# TECHNICAL BULLETIN EN-36

DATE: NOVEMBER 17, 2005  
MODEL YEAR: 2005 AND AFTER  
ENGINE MODEL: J05D-TA/J08E-TE  
CHASSIS MODEL: ALL  
BULLETIN NUMBER: EN-36

## CONNECTING ROD CHANGES

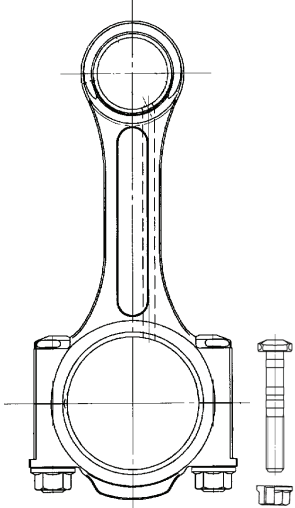
**Current Production Connecting Rods:** The connecting rod assemblies used in production engines after the listed engine serial numbers incorporate a wider connecting rod bearing and a relocated bearing locating tang. The current production connecting rods cannot be interchanged with the original and intermediate style connecting rod designs. See the following page for details.

The position of the locating tang and the width of rod bearing have changed.

**Original**  
(Original Style)

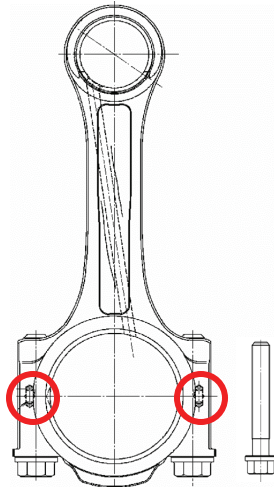
**Original and Intermediate Style Connecting Rods:** These Connecting Rods shown in the schematic on page 2 of 2 may have been mixed within engines during factory assembly.

Stud/Nut Style

**Intermediate**  
(Second Style)

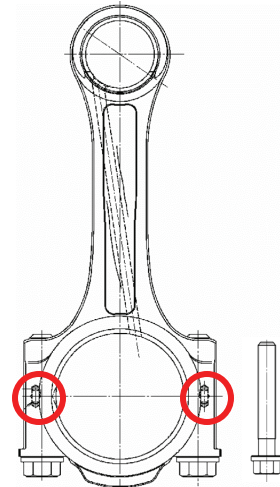
**Intermediate Style Connecting Rod:** Available as a spare part for engines prior to the listed serial numbers. This connecting rod may be used to replace the original and intermediate style connecting rods.

Dowel pins added and changed to bolt style
